ISSUE: Certificate of Appropriateness for New Construction

APPLICANT: PT Blooms LLC

LOCATION: Old and Historic Alexandria District
805, 809, 811, 815, and 823 North Columbus Street

Figure 6: Proposed balconies at alley elevation

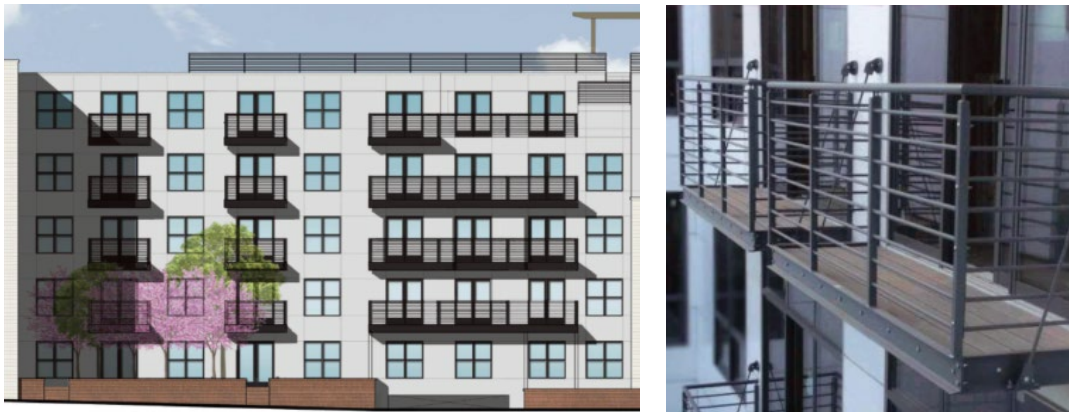
The design for the balconies has been further clarified from the previous submissions. The applicant is proposing to use prefabricated black aluminum balconies with horizontal rails. In the previous submission, the balconies at the alley elevation included vertical posts creating stacking balconies. In the current submission, the vertical posts have been eliminated and the balconies are attached to the exterior wall through the use of tension rods. This gives the balconies a more horizontal proportion that is more compatible with the overall elevation (Figure 6).

Figure 9: Site section showing proposed building with hotel and existing residential structures

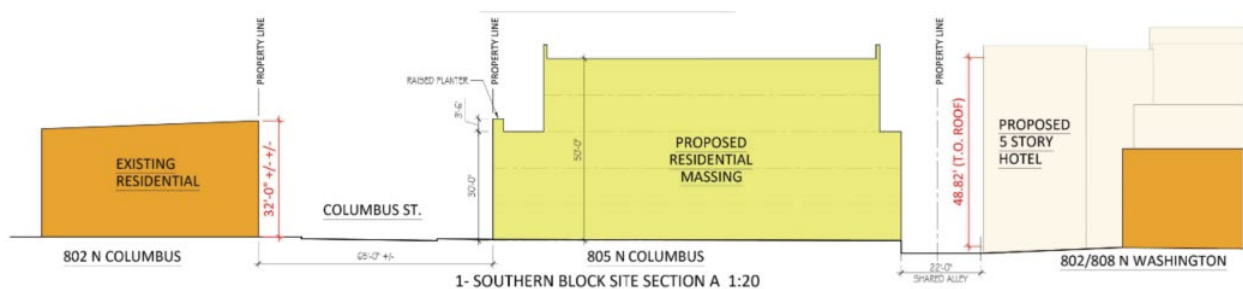
During the concept review process, the applicant modified the design in response to Board comments to include entries directly from the sidewalk into ground floor units to make the building more friendly to the sidewalk and compatible with the residential buildings found in this area of the historic district. The design was also revised to make the main building entry, which is located at the mid-point of the North Columbus Street side of the building and recessed at the rear of the entry plaza, a prominent and easily identifiable building element. This section of the building features large windows with black metal clad oversized frames. The applicant is proposing to break up the lower portions of the three story sections of the building with hyphens in the same architectural language and featuring large windows that extend to the ground (Figure 10). These building hyphens help to break up the massing to create a proportion that is similar to the historic school that was once located nearby. The use of an architectural language that is similar to the main building entry and the proximity of the hyphens to the ground floor unit entries leads to some confusion regarding the hierarchy of building entries. Staff recommends that the applicant work with staff on the detailing of these areas to create an element that is at once compatible with the other metal portions of the building while respecting the building hierarchy.
